| Project                      | <b>IEEE 802.16 Broadband Wireless Access Working Group</b> < <a href="http://ieee802.org/16">http://ieee802.org/16</a> >  |  |
| Title                        | Problem in Interleaver and Permutation Combination in OFDMA   |  |
| Re:                          | IEEE P802.16-2004/Cor1-D1   |  |
| Abstract                     | Correct the misfortunate combination of interleaver and permutation   |  |

**Figure 1: Worst case scenario of permutation-interleaver combination**

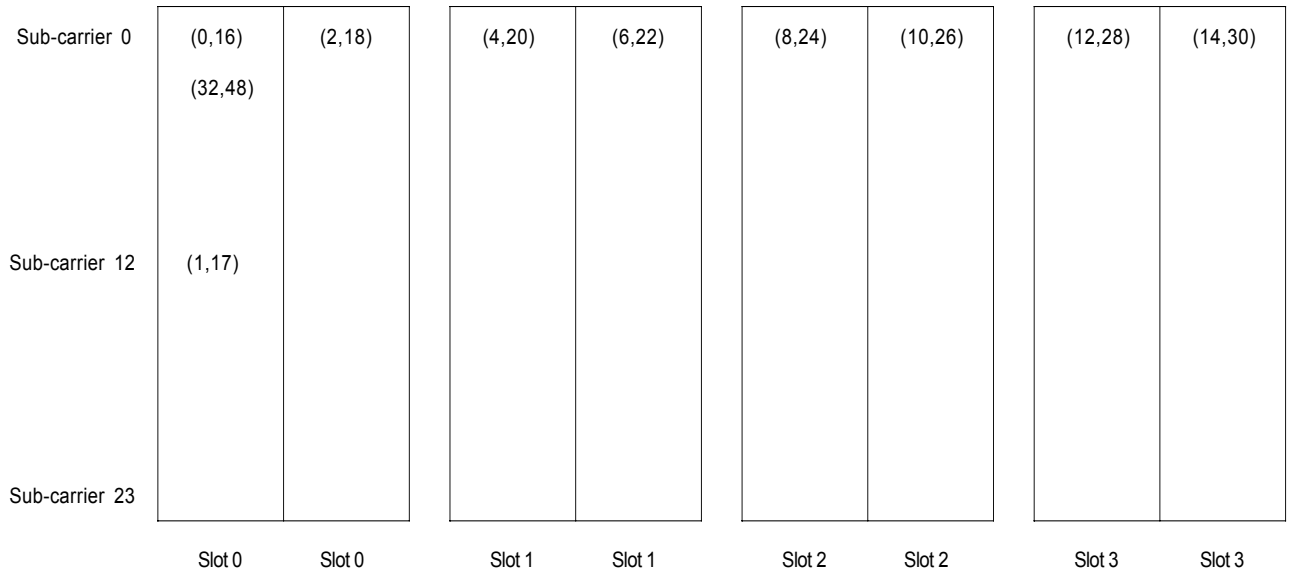
The interleaver definition with  $d=16$  might cause a performance degradation in some cases, due to a disastrous combination of interleaving and permutation. This is because, in OFDMA, the permutation actually performs an “interleaving like” operation, which partially reverse the current interleaver operation. This performance degradation occurs with burst allocations having low frequency diversity, for example bursts allocated to a single sub-channel. In these cases, adjacent coded bits might be transmitted on the same sub-carrier. Thus the interleaver operation becomes useless.

With the current interleaver dimension  $d = 16$ , for a worst case scenario (DL PUSC, burst allocation of 1 sub-channel, 4 slots in a FEC block, QPSK constellation) this period can be as small as 2 bits !! This example is depicted in Figure 1 where the numbers in brackets are the indices of the coded bits before the interleaver.

**Figure 3: Sub-carrier reordering**

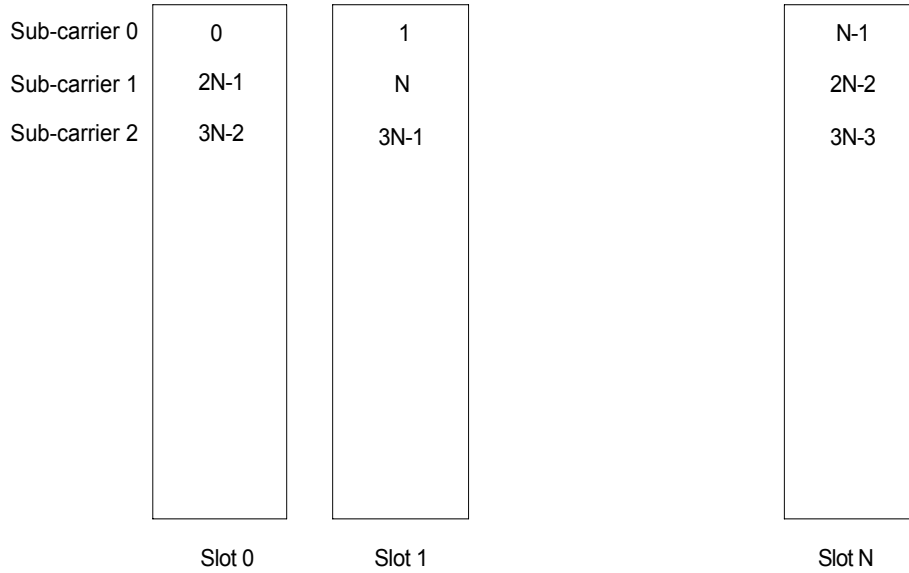
Use the same interleaver (with interleaver dimension equals 6 / 12 in the UL / DL respectively), however reorder the sub-carriers in the FEC block. The purpose of this reordering is to gather adjacent sub-carriers in frequency domain and in time domain, so that adjacent sub-carriers in the interleaver input will have significant correlation. The proposed reordering operation is depicted in Figure 3:

In order to do the reordering properly, we need to remove the in-slot rotation, for both DL and UL. Removal of the in-slot rotation requires a change in the way repetition is done. We suggest that each slot shall be rotated by  $48 \cdot n / R$  subcarriers where R is the number of repetition and n is the repetition index (0 .. R-1).

Figure 4: FEC block correlation after correction

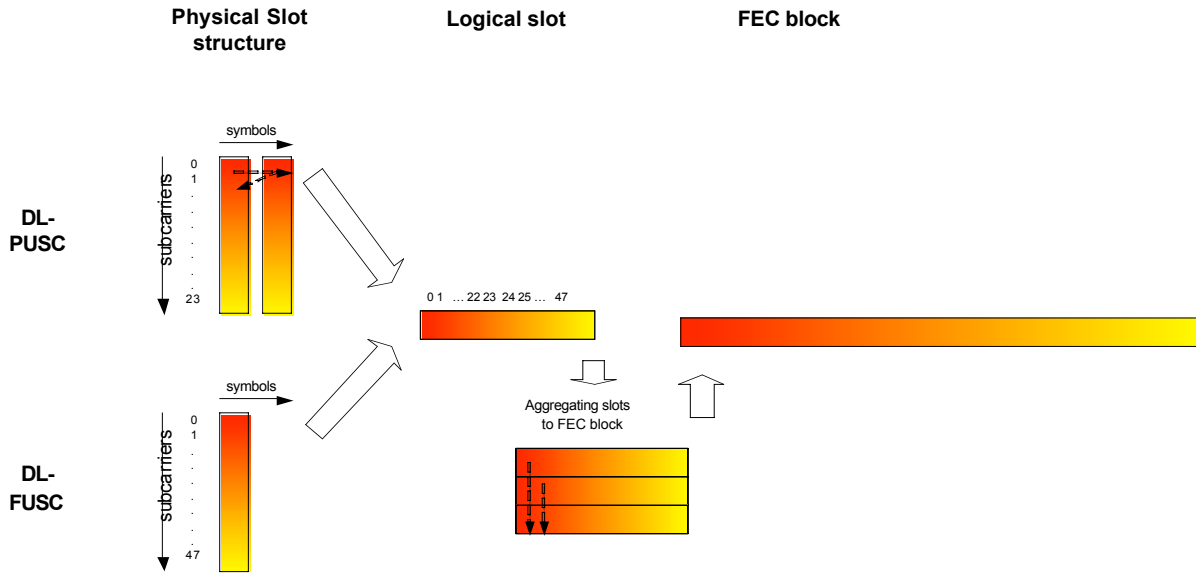
After this remedy is applied the correlation structure in a FEC block before de-interleaving will look as follows:
